YARRA CITY COUNCIL
Internal Development Approvals Committee
Agenda

1.1 PLN19/0241 - 7/1 Bik Lane, Fitzroy North - Development of the land for the construction of 4 dwellings and a reduction in the car parking requirement

1. This report provides an assessment of the development of the site at No. 7/1 Bik Lane, Fitzroy North for the construction of four dwellings and a reduction in the associated car parking requirement of the Scheme.

1.2 PLN19/0663 - 151 Barkly Avenue, Burnley - Construction and display of an electronic, major promotional, sky sign

Figure 5 – North elevation

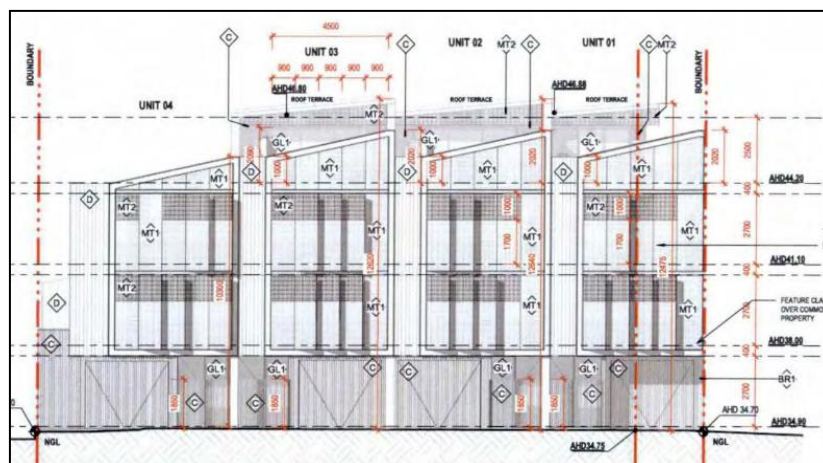
91. The northern façade extends up three storeys, with a recessed fourth level. Clause 22.10-3.3 of the Scheme encourages the use of massing or articulation or changes of surface treatment, or a combination of these, to relate taller buildings to the scale of their surrounds, and to diminish visual bulk. They also seek the use of appropriate materials, finishes and colours, which add visual interest and, assist in breaking up the mass and bulk of new development. To provide articulation, the facade incorporates a mix of cassette panel cladding and perforated metal in a powdercoated black finish. The vertical cassette panel cladding provides a break between the perforated metal and differentiates between the dwellings, in line with the dwelling entries (figure 5). The incorporation of a saw tooth roof line to the terraces respects the commonly found roof design within the Bik Lane subdivision.

Figure 6 – First floor plan

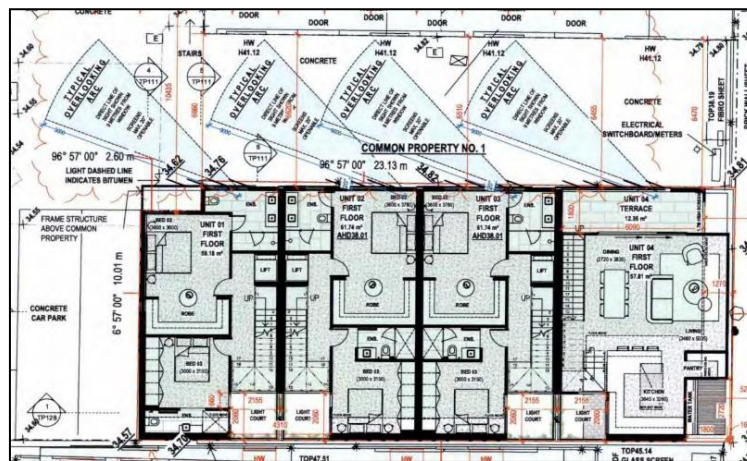
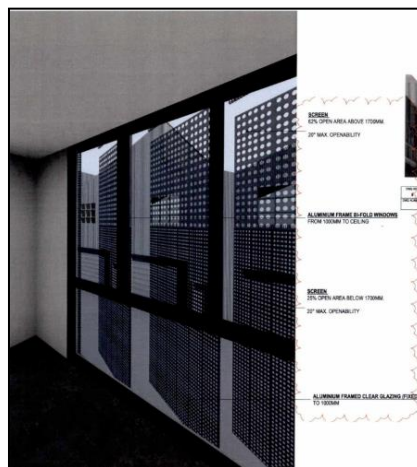
92. Due to the proximity of adjoining habitable room windows to the north, perforated metal screens have been incorporated along the first and second floors to prevent overlooking. This does reduce the level of street activation and has been raised as a concern by Council's Urban Design Unit. To provide some outlook and visual interest the applicant has incorporated perforated metal which will allow for some outlook. In addition, restricted opening of 20 degrees have been incorporated along both levels to allow for some passive surveillance onto the common property (figures 6 and 7).

Figure 9 - Endorsed plans (north elevation) - No. 4 Bik Lane – PL07/1209

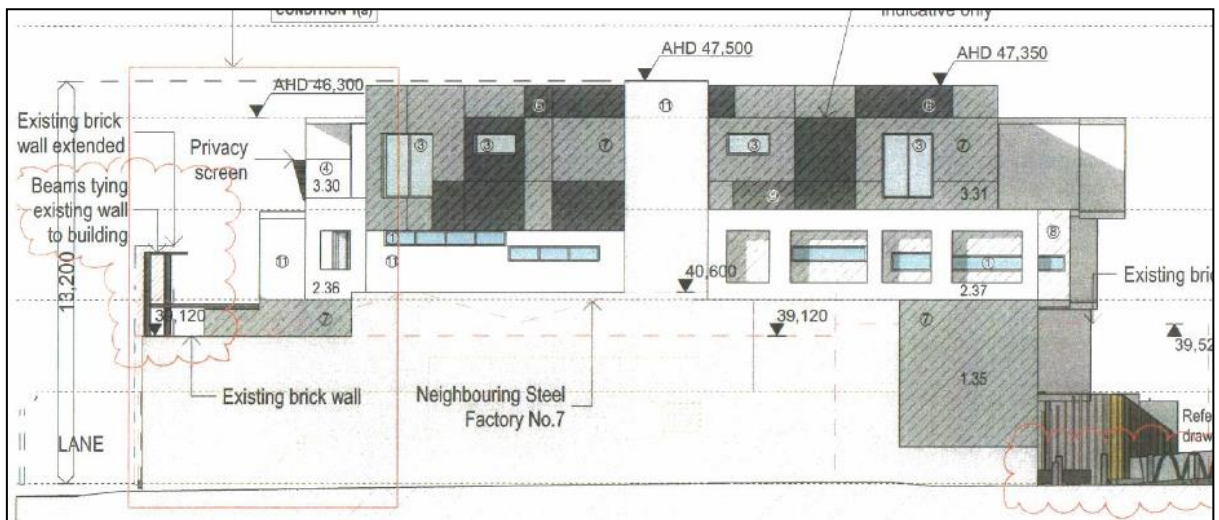
- (a) There are examples of boundary walls constructed in excess of the above standard within the immediate area, with No. 4 Bik Lane to the south having a four storey wall constructed to the boundary (figure 9).
- (b) The southern boundary wall is largely constructed adjacent to an existing four storey boundary wall associated with No. 4 Bik Lane (figure 9).

Figure 10 – Typical overlooking section from roof terrace

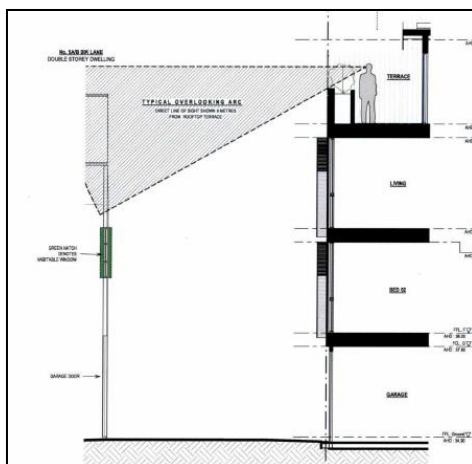
144. Dwellings 1-3 are proposed to have north-facing terraces at the third floor (rooftop level). To prevent overlooking into habitable room windows at 5/1 and 6/1 Bik Lane, it is proposed to use a combination of planter boxes 2m high wall associated with the sawtooth roof profile. Typical overlooking diagrams have been provided which demonstrates that no overlooking occurs (figure 10).

145. This section is applicable to all of the terraces and windows to the north, with these located along the same level and of the same proportion (figure 11).
